**AGENDA
CITY OF CEDAR FALLS, IOWA
PLANNING AND ZONING COMMISSION MEETING
WEDNESDAY, DECEMBER 22, 2021
5:30 PM AT CITY HALL**

TO: Planning and Zoning Commission
FROM: Michelle Pezley, Planner III
Matt Tolan, PE, Civil Engineer
DATE: December 3, 2021 updated December 17, 2021
SUBJECT: West Viking Road Industrial Park Phase V and VI Preliminary Plat (PP21-007)

TO: Planning & Zoning Commission
FROM: Stephanie Houk Sheetz, AICP, Director of Community Development
DATE: December 15, 2021
SUBJECT: River Place Plaza Site Plan Amendment (Lot 3 River Place 3rd Addition) (SP21-017)

TO: Planning & Zoning Commission
FROM: Stephanie Houk Sheetz, Director of Community Development
DATE: March 4, 2020
SUBJECT: Site Plan Review for the Plaza at River Place Properties

Phasing of Development and Street Network:

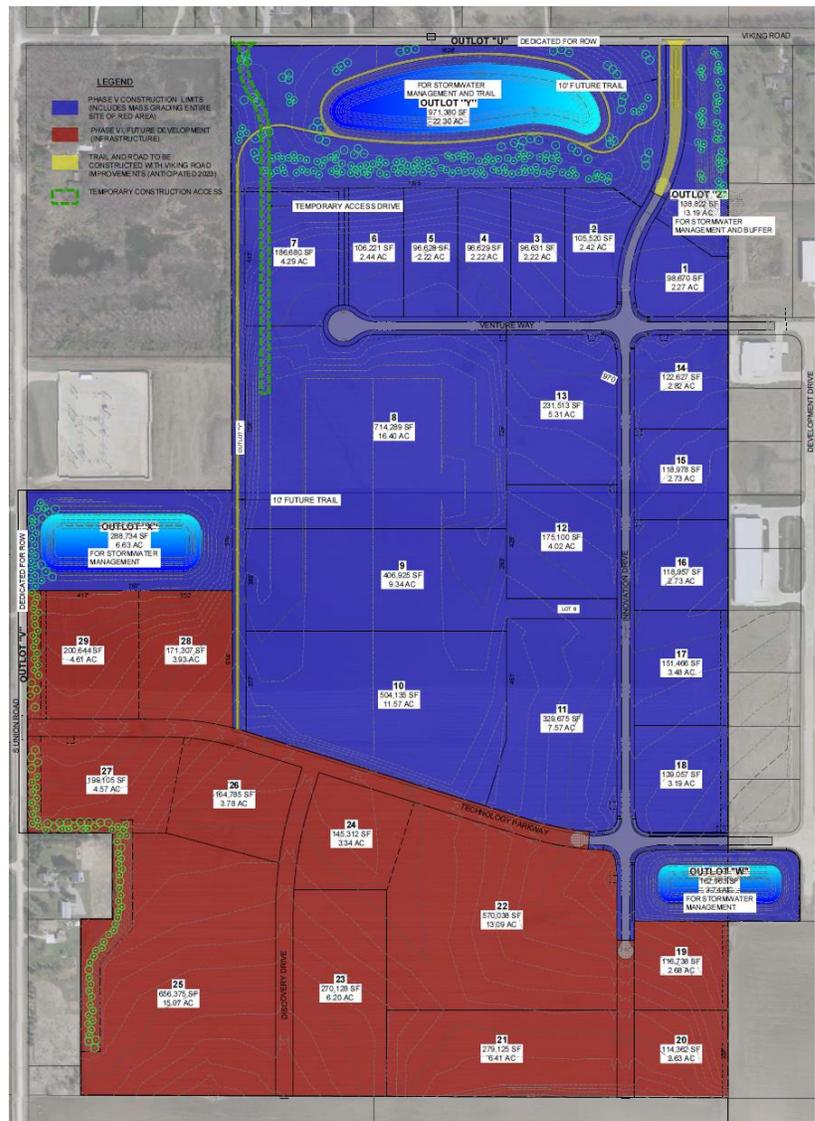
The phasing plan also indicates that the street connection to W. Viking Road will not be completed until the full reconstruction of W. Viking Road. This will ensure that road construction traffic for Phase V will be routed through the existing Industrial Park along Venture Way and Technology Parkway. Phase VI will include all the lots shown in red and include the final extension of all streets to the industrial park boundary, including the connection to W. Viking Road, Union Road, and to the south property boundary. It is anticipated that W. Viking Road will be improved to Union Road in 2023 to bring it up to City street standards prior to completing the northernmost segment of Innovation Drive where it will intersect with the improved W. Viking Road. The street intersections, cul-de-sac, and curves will be designed for a semi-truck trailer to have adequate moving room within the subdivision.

While the access road for temporary construction of one of the sites is not part of the plat, staff wanted to verify where construction traffic will be routed as shown in the updated phasing plan.

The City expects to convey Lot 8 to a new owner prior to completing the public improvements. A temporary construction access will be established to allow construction to commence on this lot concurrently with construction of the public streets. Once one of the street connections is completed to the existing industrial park, the temporary road will be removed. From that point on all the construction traffic for Phase V will be routed through the existing industrial park. The City's preferred route for the temporary access road is shown on the attached phasing plan. The city anticipates that the temporary access road will only be needed for approximately 3 months beginning in August, 2022.

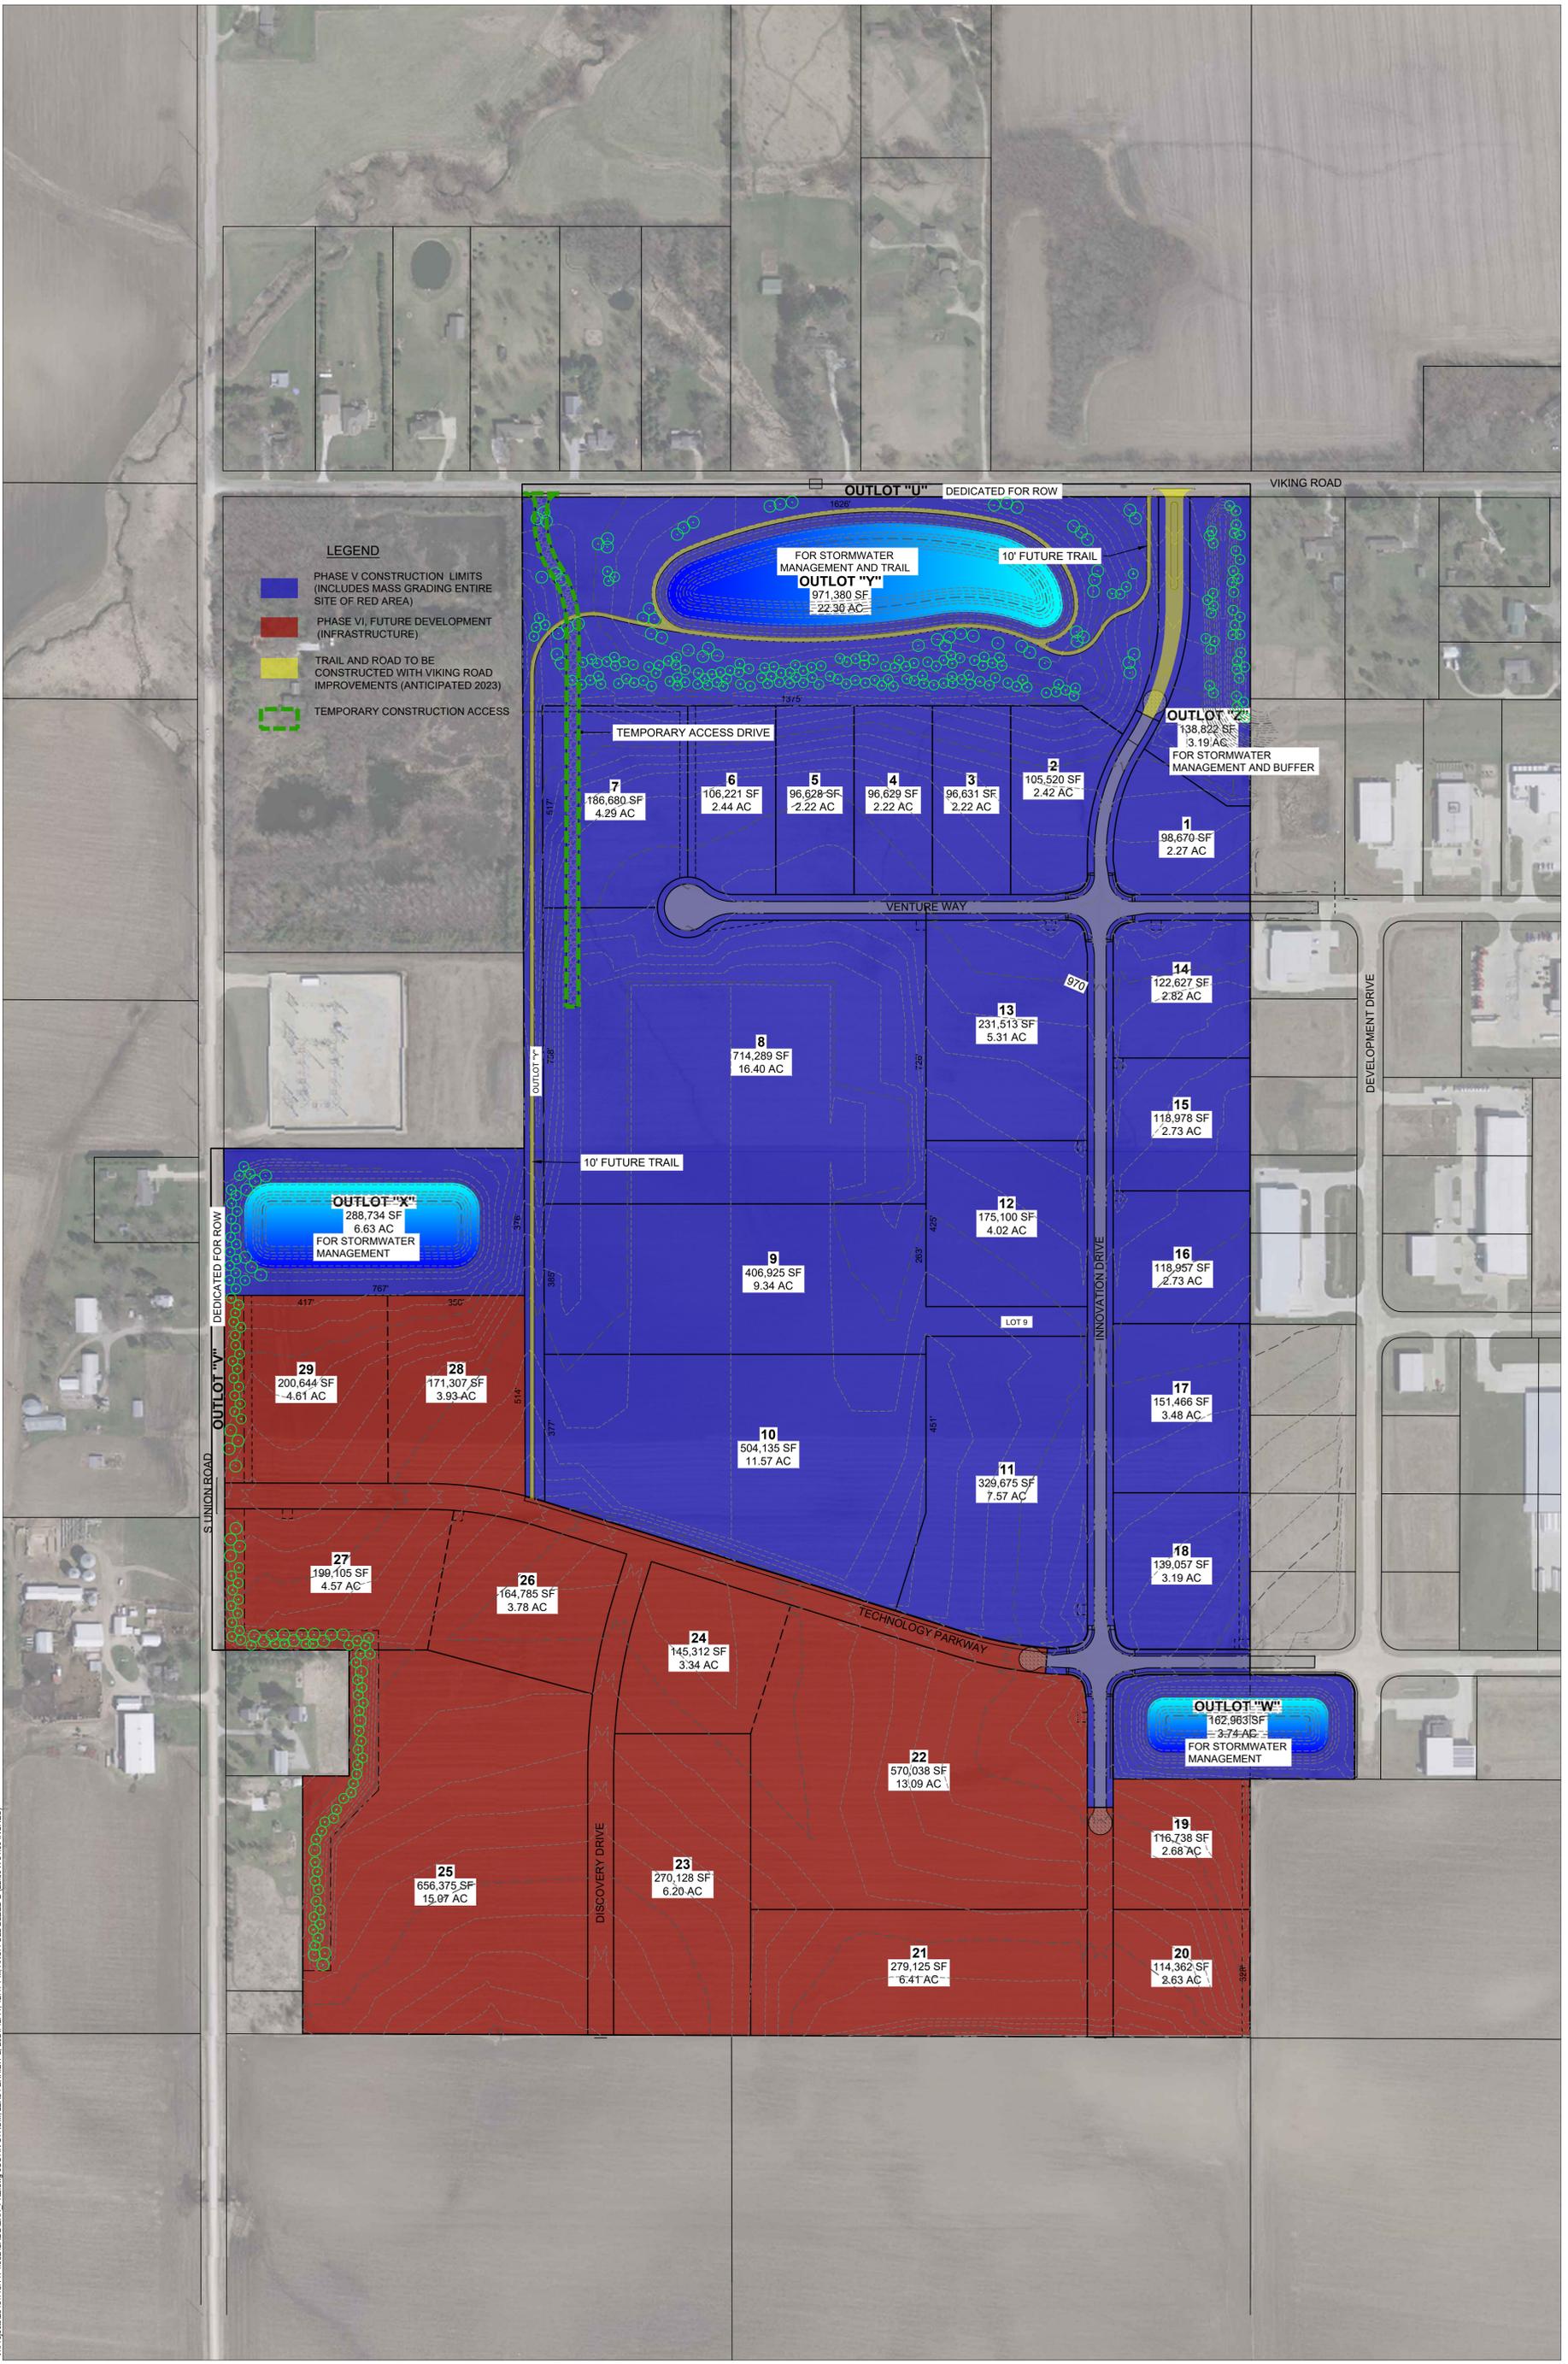
1. Traffic safety: The proposal of the access road at the west side of the development property entering Viking Rd is a blind spot safety concern. The sketch drawn shows the proposed road in place of the field gate access established today. Since 2009 when we moved in, my wife and I have watched farm equipment enter and exit from this spot. This fall we also were able to watch the city of cedar falls haul compost to the property with the tandem axle trucks. In both cases, we have seen trucks pull out of the field gate into oncoming traffic coming from the west. The trees along the fence line and road ditch on the south side of the road prevent clear vision from the access gate.

2. Construction traffic adds to busy traffic. Since first hearing about the project, as noted in the Planning and Zoning Committee meeting packet, the neighborhood has been concerned with the extra traffic that the expansion would bring to Viking Road. The proposed temporary access road from Union Road would help address these concerns. Union Road was used as an access point for the recent electrical substation project. Could this be an option for the industrial park early access?

2020 Proposal:

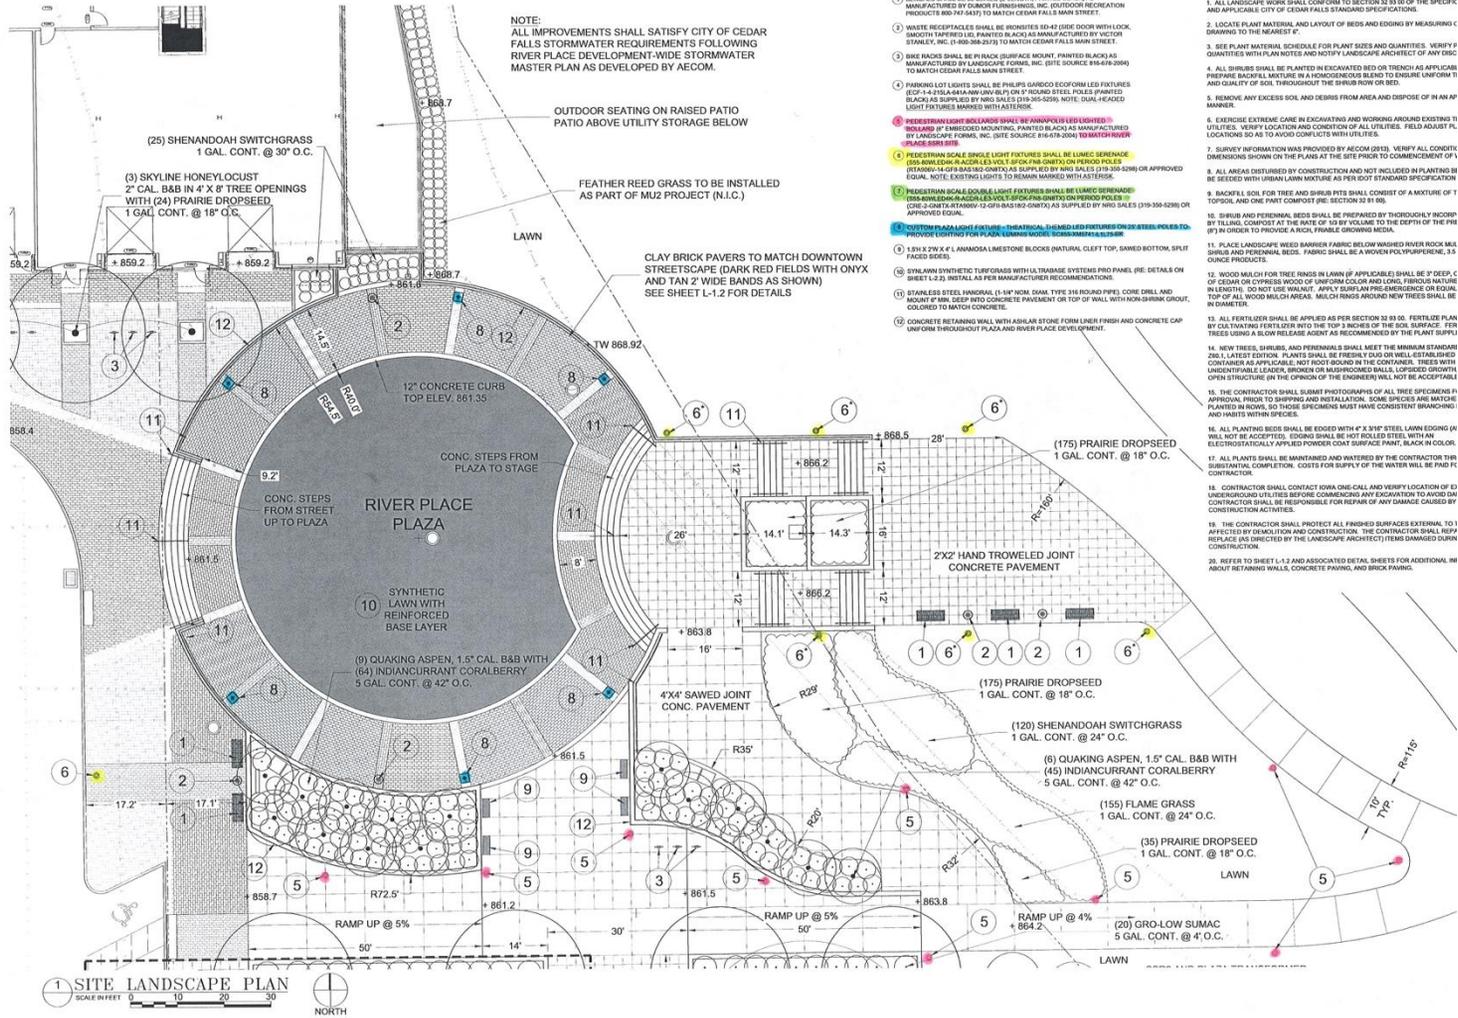
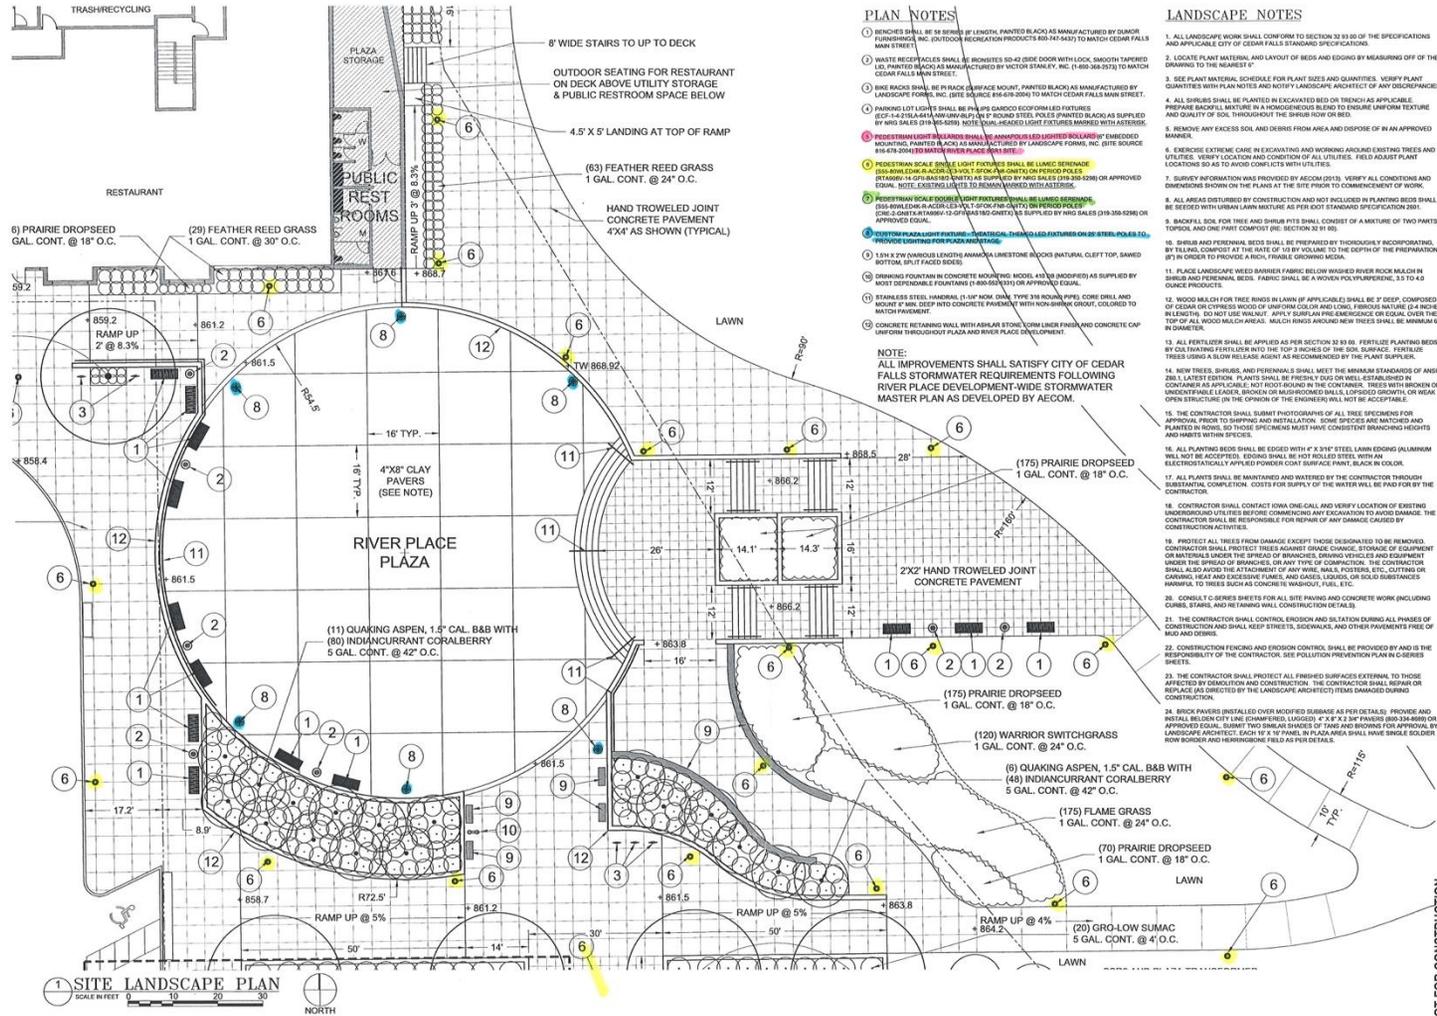
The approved 2016 plaza site plan shows 21 Lumec Serenade decorative lights. The intent of the plan was to match the decorative lights on 2nd St. and those yet to be installed by the developer along the east side of State Street. The change proposed in the construction plans is to provide seven single-head Lumec lights, replacing others with lower level bollard lighting. Ten bollard lights are proposed. This change is proposed after the Developer completed a photometric plan, which showed the area is overly lit under the 2016 plan. It showed foot-candles of 1.5 – 2.0, depending upon the location. For comparison, twilight produces about 1 foot-candle. Once dark, lighting can often seem brighter. When there's ambient lighting (other lights such as street lights), less lighting is needed since they support each other. Staff agrees too much lighting can be a nuisance and considering a reduction is appropriate, based on the photometric plan.

The style of lighting is another point of review. Below, staff provides a highlighted version of the site plan, enabling a quick review of the lighting types and locations. The decorative light matching the streetscape (Lumec Serenade) would be along the street and up the stairs on the east side of the Plaza. The bollards are proposed along the area south of the Plaza (along the trails heading east connecting to the levee trail). The style of bollards proposed match those found in the back areas of the River Place development. Theatrical lights are within the Plaza. Outside of planned events, it is anticipated they will provide some lighting for the area until approximately 10 p.m. The brightness and timing will be monitored and adjusted as needed.

The intent has been that the Plaza complements the downtown streetscaping. Staff feels the changes proposed accomplish this. Streetscape lights are used in the focal areas, while different lighting is to the south side of the site, providing continuity with the River Place development. Theatrical lights remain consistent in their use and general location from 2016 to 2020. The poles are simple 6" round poles, to be painted black.

2020 Proposed Plan

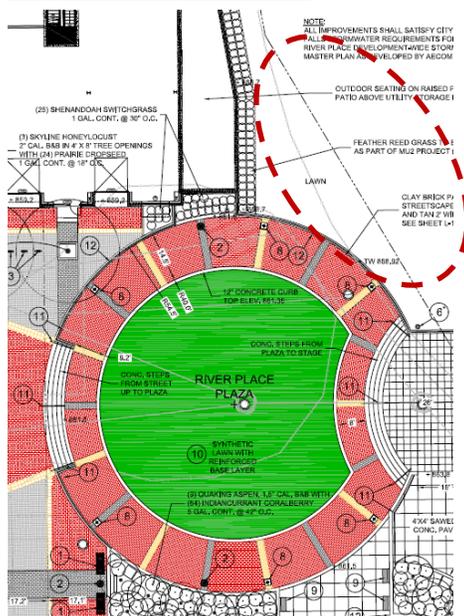
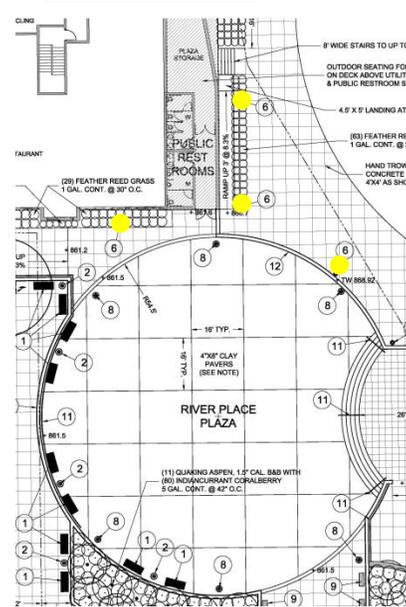
Area lighting has been removed on the north side of the Plaza, circled in red on the 2020 plan below. Originally, the developer anticipated steps from the residential area (in the MU2 building) to a gathering area on the north side of the Plaza. This area was also going to be generally level with the levee and feature concrete walking/gathering area. This is no longer planned due to several factors. This area is now proposed for seeding and landscaping. The public and residents will not be encouraged to heavily use this area; therefore ambient lighting from the Plaza will be sufficient. The Developer also plans to add landscaping along the north wall of the Plaza, which will add decorative features while discouraging heavy use of that area.

A decorative light has been removed from the street edge, near the staircase from the sidewalk to Plaza. This seems appropriate for several reasons: it removes visual barriers to the Plaza, removes a conflict with the brick pattern for this area, and improves spacing of lighting given a double head light is on the north side of E 2nd St. Staff requested a double head light be located at the southeast corner of the State Street/2nd St. intersection, to complement the pattern of double-head lights found at most downtown intersections. The Developer is updating the plans to make that change.
